16 April 2019

**RE: MOOLARBEN COAL COMPLEX – OPEN CUT OPTIMISATION MODIFICATION (05_0117 MOD 14)
AND (08_0135 MOD 3) – RESPONSES TO REQUESTS FOR FURTHER INFORMATION**

Enclosure 1 Responses to IPC Request for Further Information

Figure 1
UG4 (Moolarben Coal Complex) and
Ulan East Pit (Ulan Mine Complex)

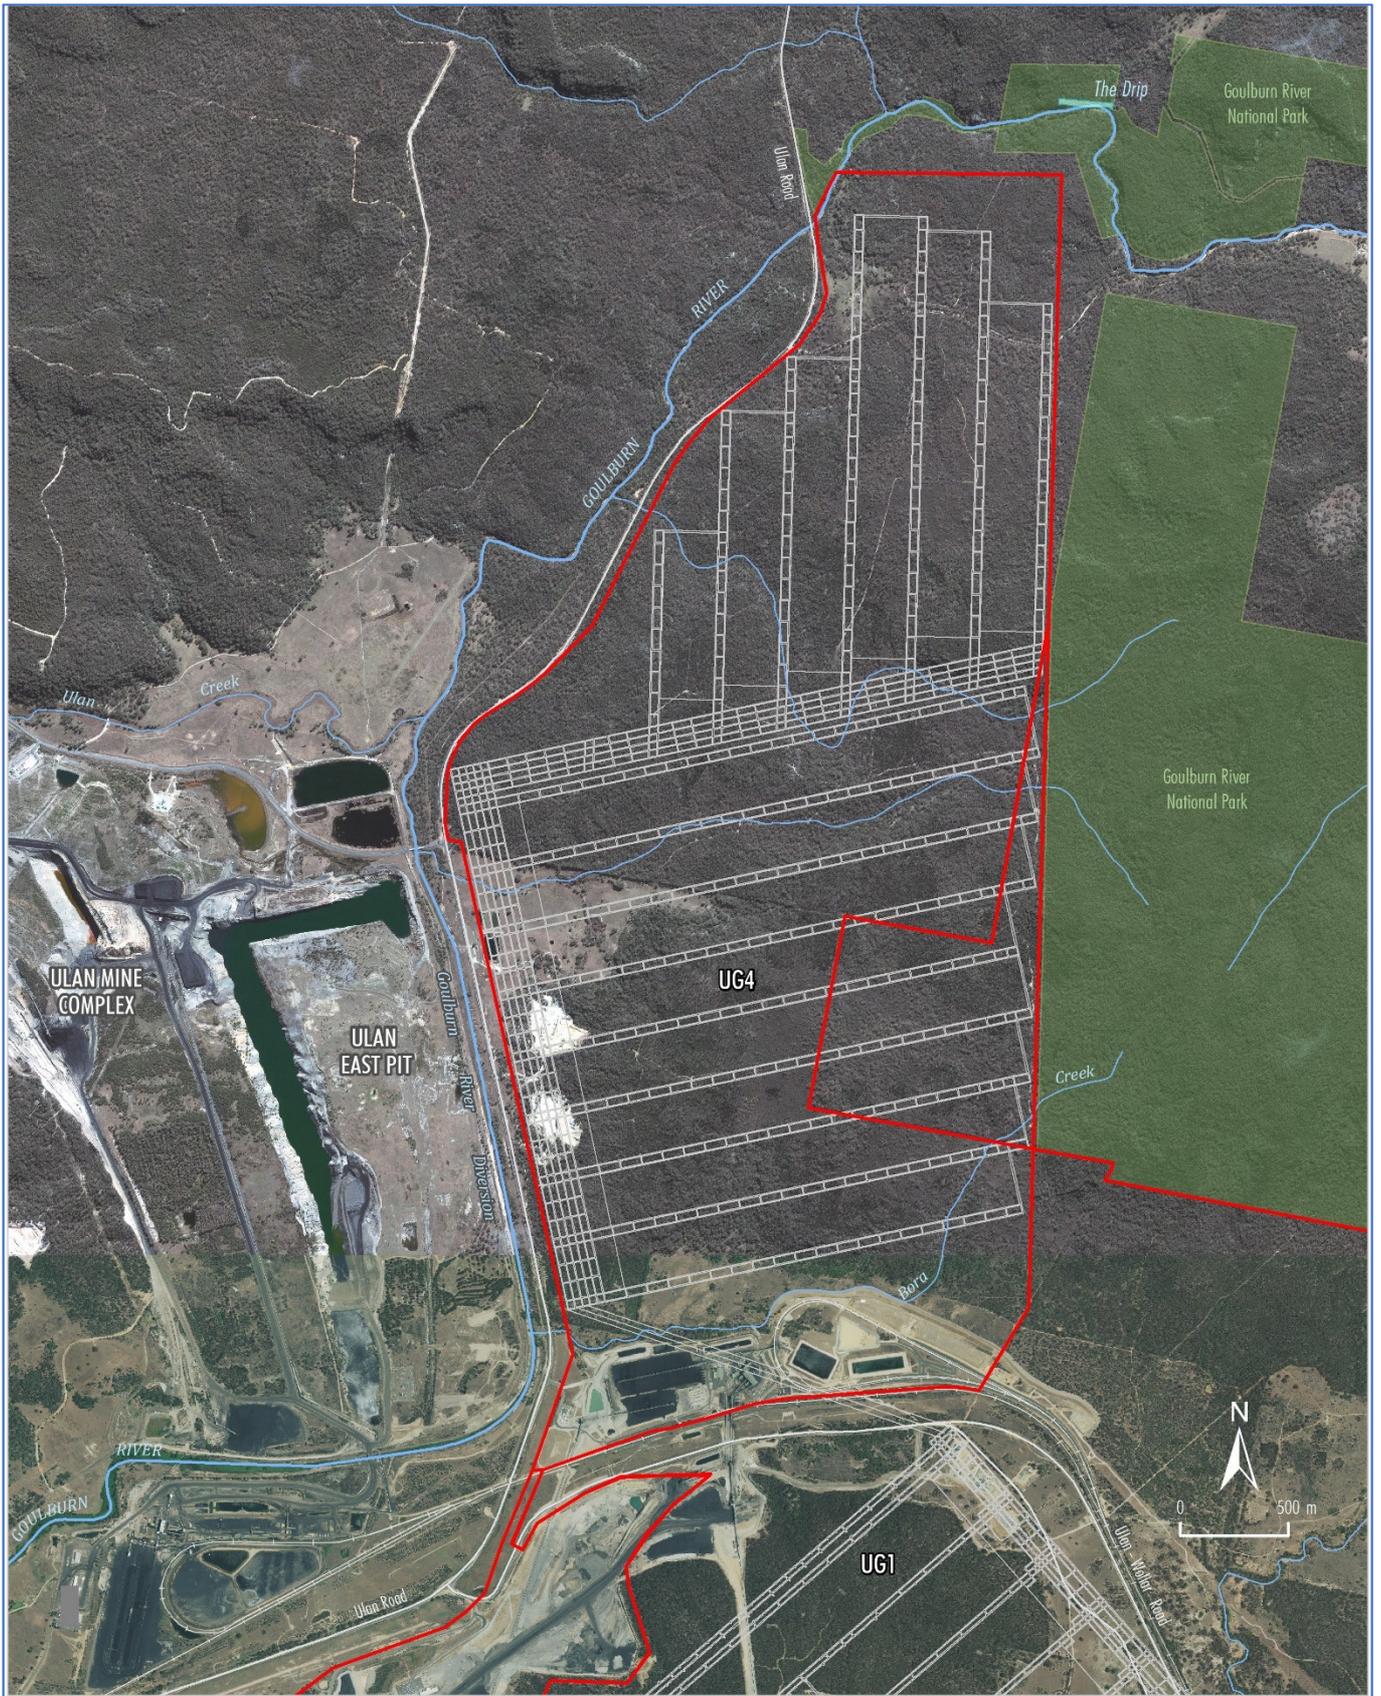
From the above, the Commission panel would like for the proponent to elaborate on the scope of the original model or details of the project that were not included or considered in the original model, which are now considered in the new model resulting in a doubling of the discharge limits. Why were those details not included in the original model? If the MODFLOW-SURFACT was used to update the model, would it had shown similar results to the ALGOMESH? Is the doubling of discharges related to the proposed increase in coal production and surface disturbance?

4. Water stored in the Ulan East Pit recharging the coal seam to be mined for UG4 (note that UG4 is down dip from the Ulan East Pit), which has the potential to increase inflows to UG4 (Figure 1). Note potential recharge of the coal seam to be mined in UG4 from the Ulan East Pit was not considered a significant water source in the original Stage 1 groundwater model.

Figure 2
Hunter River Catchment

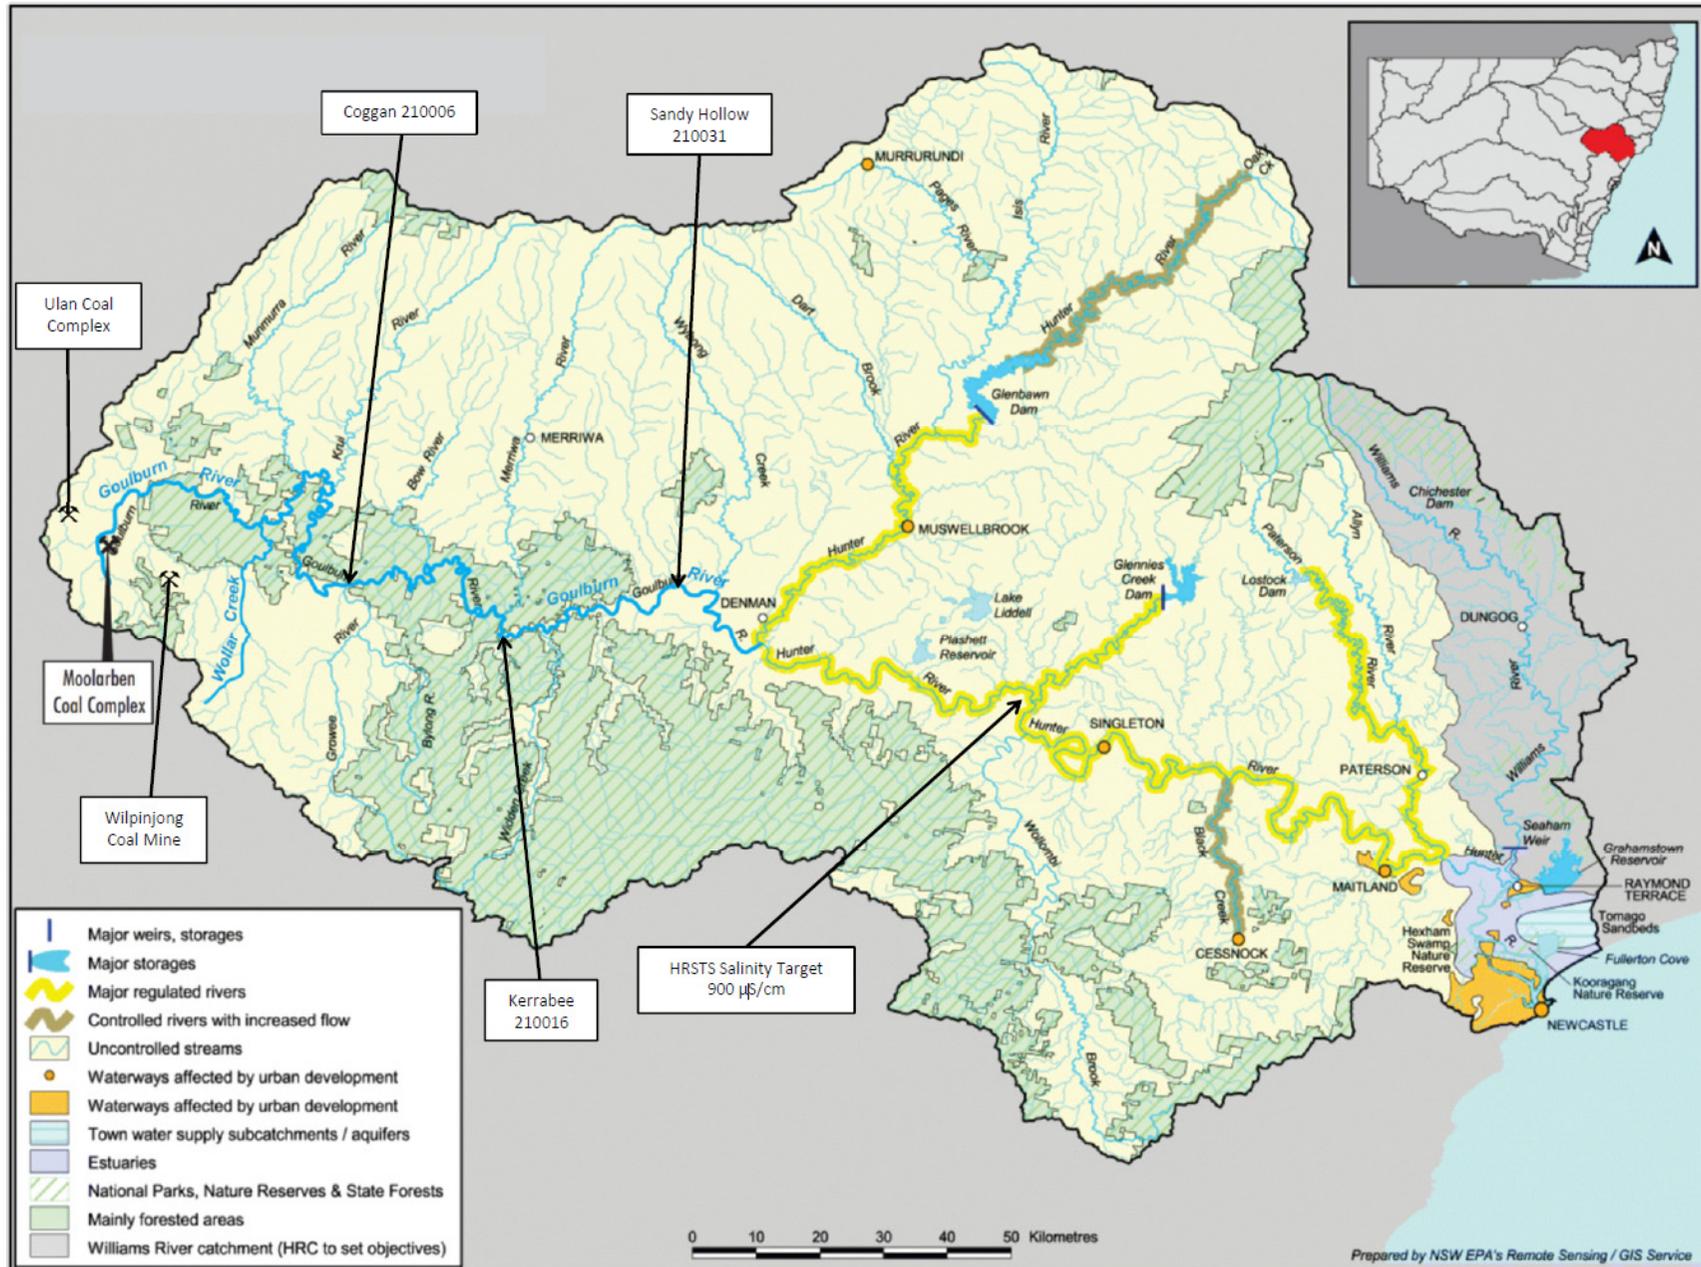
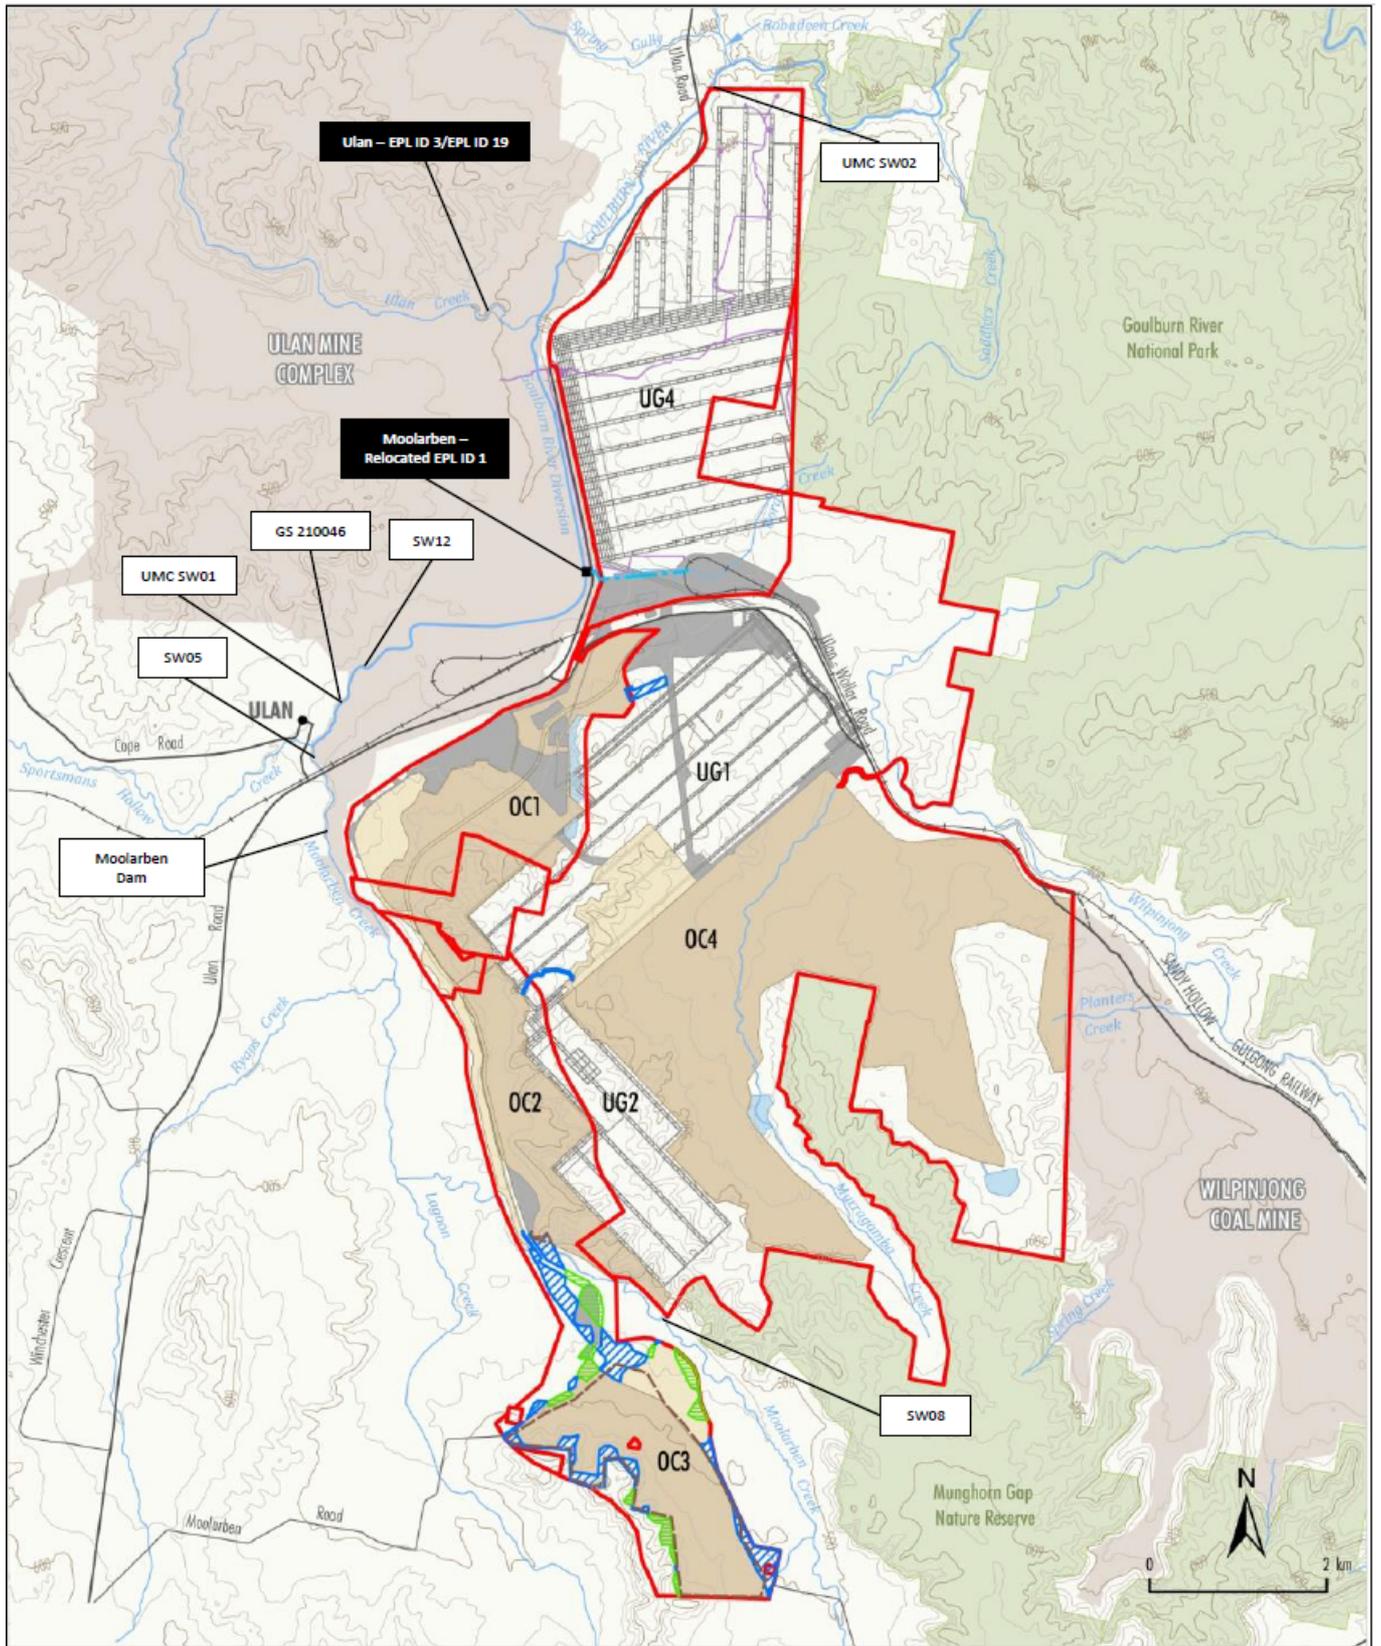
The Commission is particularly interested whether changes to the total load of salinity in the Goulburn River could potentially impact its levels, specifically at its confluence with the Hunter River and therefore impact the Hunter Salt Trading Scheme. Has the proponent undertaken any studies or assessments on the likelihood of this to occur?

Table 1 provides the 80%-ile salinity data recorded in the Goulburn River both upstream and downstream of the Moolarben Coal Complex. Upstream of the Moolarben Coal Complex (i.e. including sites unaffected by the Moolarben Coal Complex), the salinity of the Goulburn River is highly variable (i.e. up to 4,856 $\mu\text{S}/\text{cm}$). Further downstream the Goulburn River, salinity is **824 $\mu\text{S}/\text{cm}$** to **1,278 $\mu\text{S}/\text{cm}$** (Table 1). By comparison, controlled releases from the Moolarben Coal Complex would have a maximum of 685 $\mu\text{S}/\text{cm}$ and would not increase these downstream salinity levels.

[^] Refer to Figures 2 and 3 for locations
